SERVICE BULLETIN

SB1268

ADDRESSEES	: ABC Customer Care and Parts Source Owners and operators of coaches listed under 'Application'
VEHICLE MODEL	: TX40-TX45
MANUAL SECTION	: Chapter 10.10: Windshield wipers
BULLETIN TYPE	: Field Change Program
DATE	: September 09th, 2014
SUBJECT	: To prevent windshield wiper blades lifting from the windshield
TERMS & CONDITIONS	: Refer to the warranty section further in this Bulletin.

Figure 1

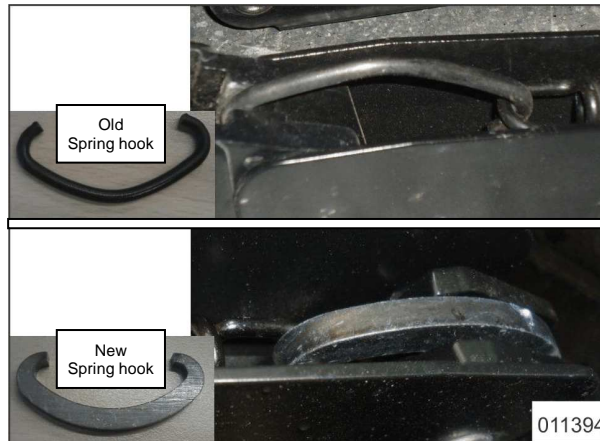
- It has been determined that under certain conditions, it is possible that the wiper blades may lift from the windshield at highway speed.
- To address this issue, DOGA and Van Hool are conducting a Field Change Program, the terms and conditions of which are explained further on under "Warranty".
- Owners and operators of the affected units should follow the procedure below to replace the wiper arms.
- Old and new wiper arms can be identified by the spring hook design located on the inside of the lower part of the arm as shown in Figure 1.

VH Reference	Description	Qty.
10951137	Wiper arm with old spring hook	2

VH Reference	Description	Qty.
11422003	Wiper arm with new spring hook	2
